For Board Meeting of: October 10, 2019  
Agenda Item: 5.a

**TO:** Salem Parks and Recreation Advisory Board  
**THROUGH:** Robert D. Chandler, PhD, PE   
**FROM:** Patricia Farrell, Parks and Natural Resources Planning Manager   
**SUBJECT:** Salem Riverfront Carousel Proposed Expansion and Location of the Salem Peace Mosaic

# SALEM RIVERFRONT CAROUSEL STABLE ADDITION

101 FRONT STREET NE - SALEM, OREGON 97301  
PROJECT NO. 18040  
SEPTEMBER 5, 2019

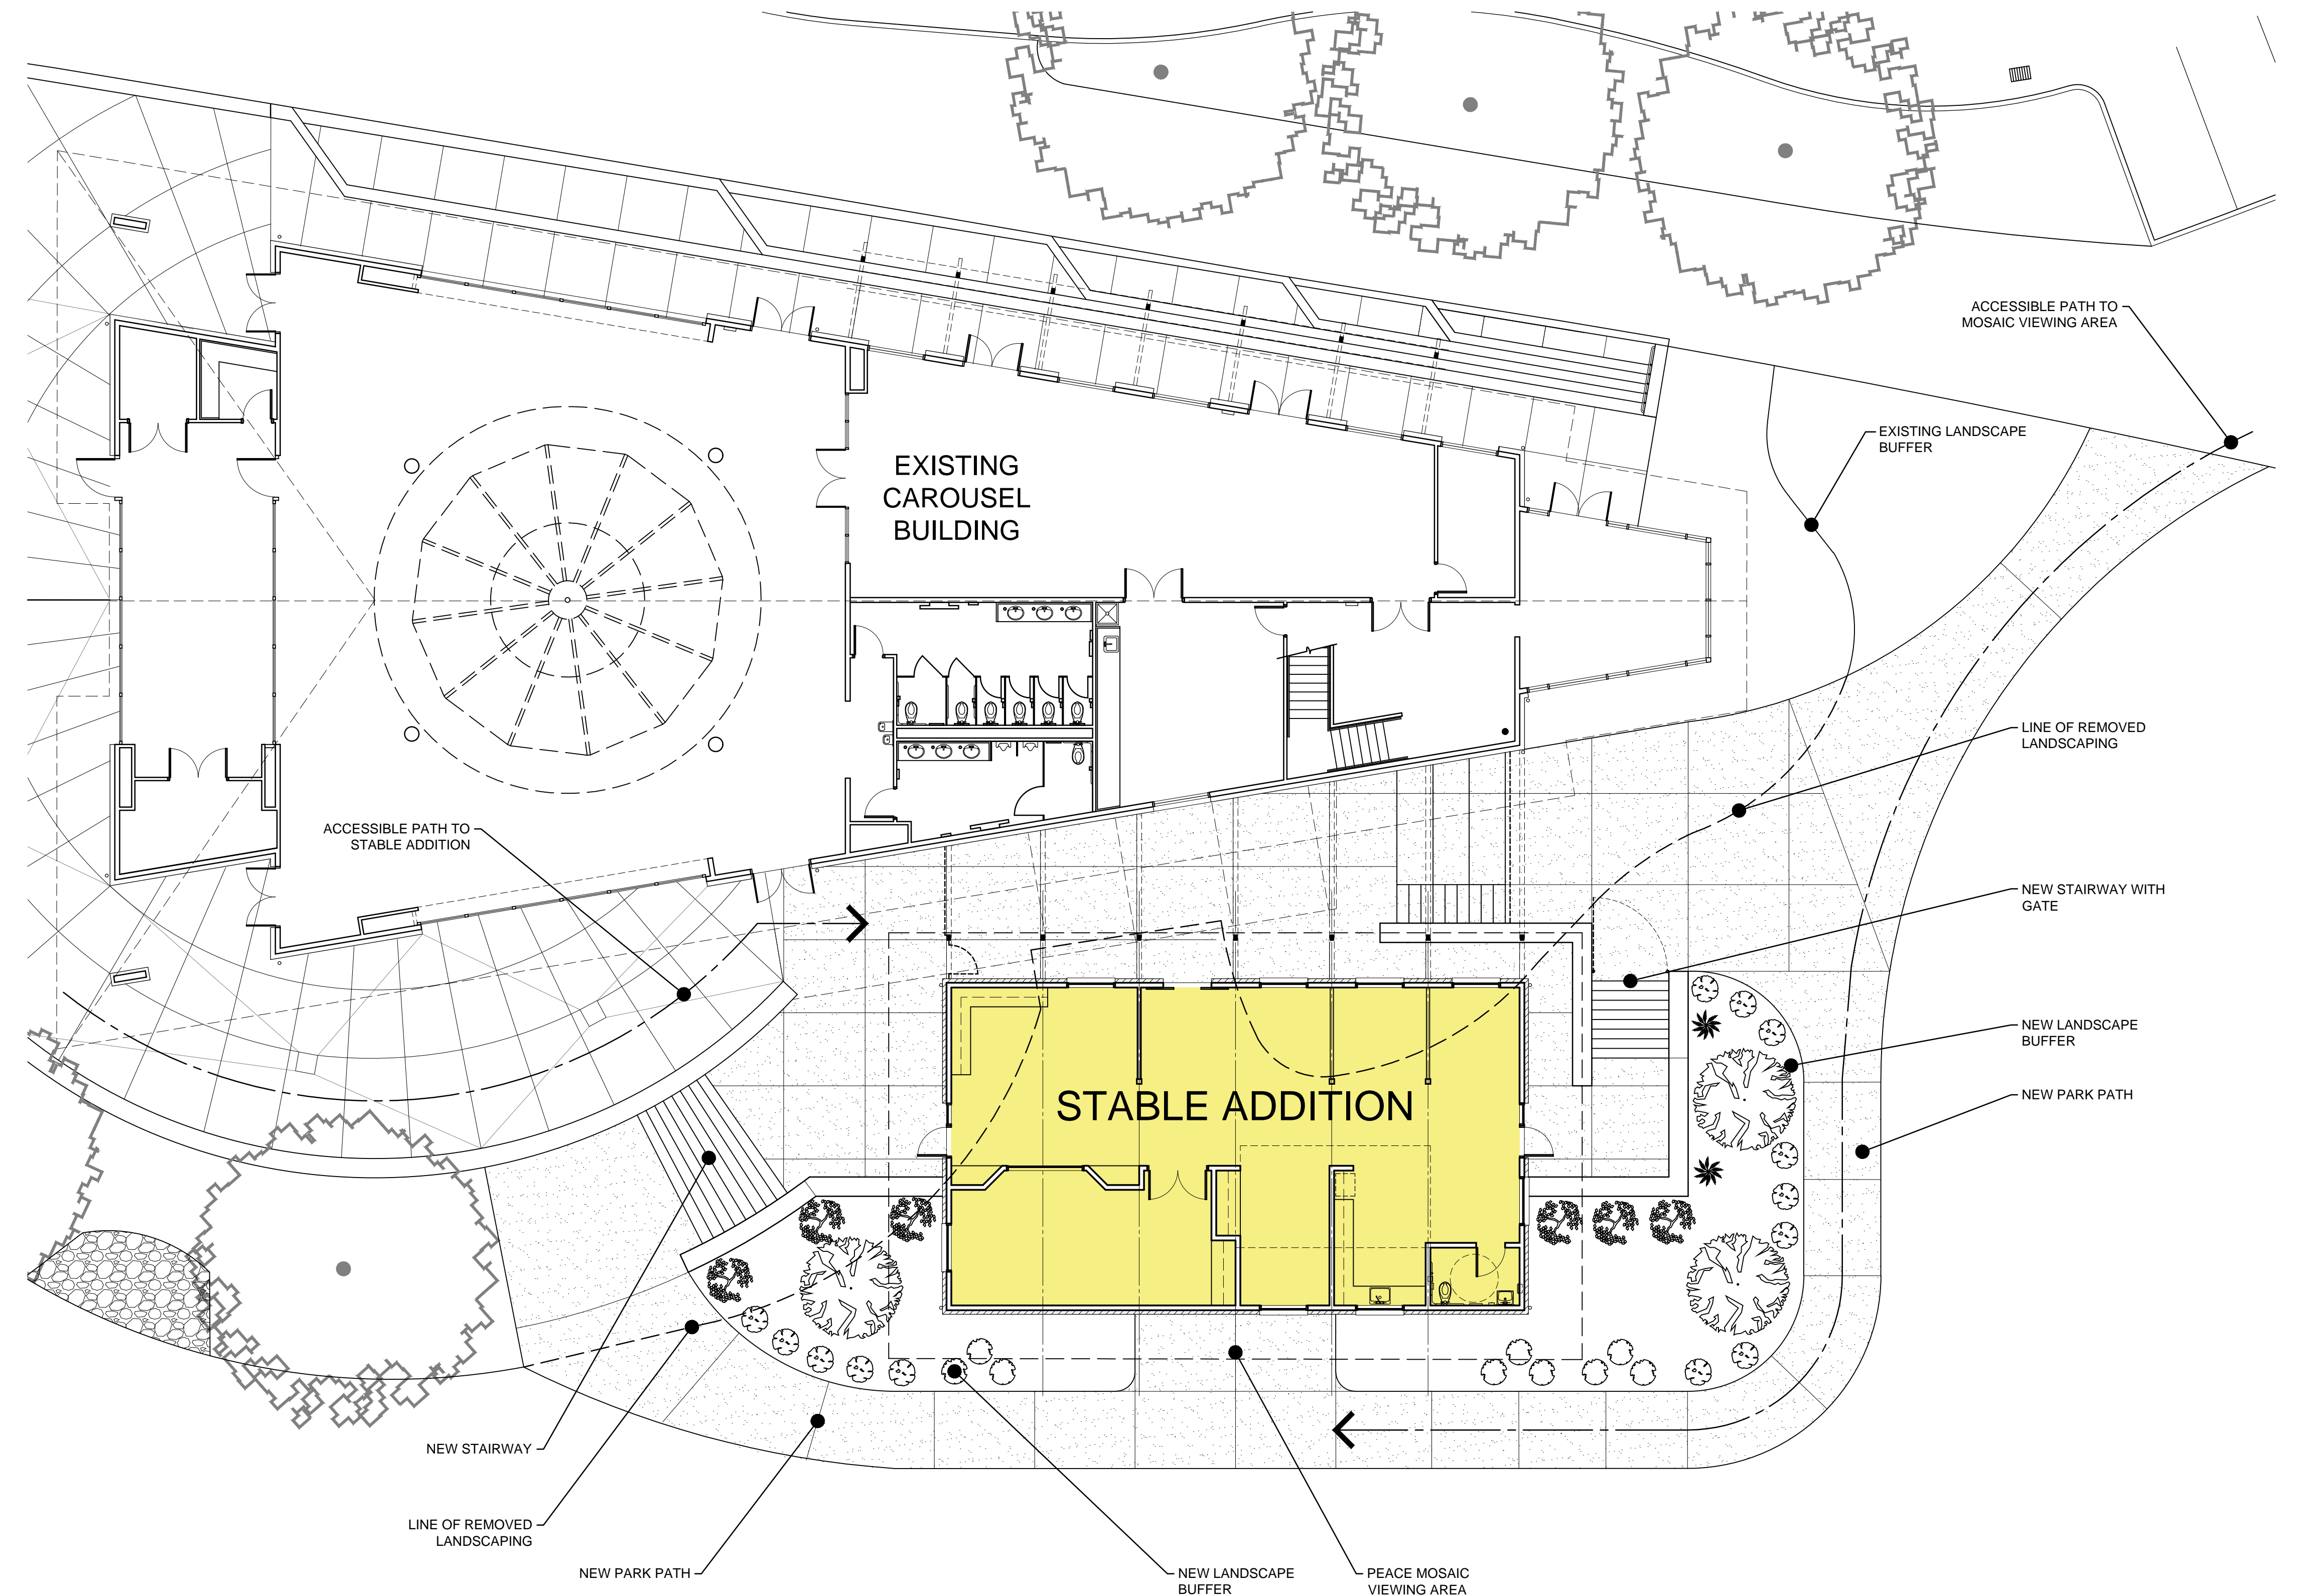
a. City Staff Request: The west-facing wall appears to draw patrons into the Carousel rather than opening into the park as an integrated feature. Please address how the facility can be better integrated into the park without expanding further into the open turf area.

b. City Staff Request: The plaza and steps between the addition and the existing building are isolated, which will become a security challenge, particularly after-hours when the park is closed. This space seems to form an autonomous area that is cut off from the park.

c. City Staff Request: Please provide a detail drawing of the landscape buffer impacts and proposed new landscaping, including a site grading plan. Show ADA accessible route to and around the building and to the glass window viewing area. Keep in mind limitations to expansion into the park. Riverfront Park's master plan calls for the maximum preservation of large open space.

d. City Staff Request: Provide an elevation view looking east from the lawn toward the building.

f. City Staff Request: Show the placement of the Peace Mosaic as it may be proposed to the Salem Public Art Commission. The mosaic should be shown in a drawing within the context of the landscape and accessible paths along the building. (Salem Public Art Commission must approve the location of the mosaic and, if that location is in a City park, SPRAB's approval must be obtained.)

AC + CO Response: The revised west view incorporates the following revisions: lower height of foundation wall; incorporate the Salem Peace Mosaic to tie into the park; lower height of stair wall; curve stair wall to integrate into the park area.

AC + CO Response: This area is envisioned as an outdoor classroom area during hours of operation. To alleviate security concerns when the park is closed, , security gates can be added to close access, as well as overhead coiling gates hidden by the trellis beams. The area is integrated into the park as per the following: building exits onto an over-look to the playground; concrete wall lowered at over-look and stair; guardrails added at over-look and stair.

AC + CO Response: Refer to updated Site Plan (Attachment 2) which illustrates the following: ADA access to building and viewing area; park path around building; added landscape buffers; minimal open park space impacts.

AC + CO Response: An updated West Elevation from open park area looking east is now included.

AC + CO Response: Park paths are now shown for viewing of the mosaic, refer to updated Site Plan.
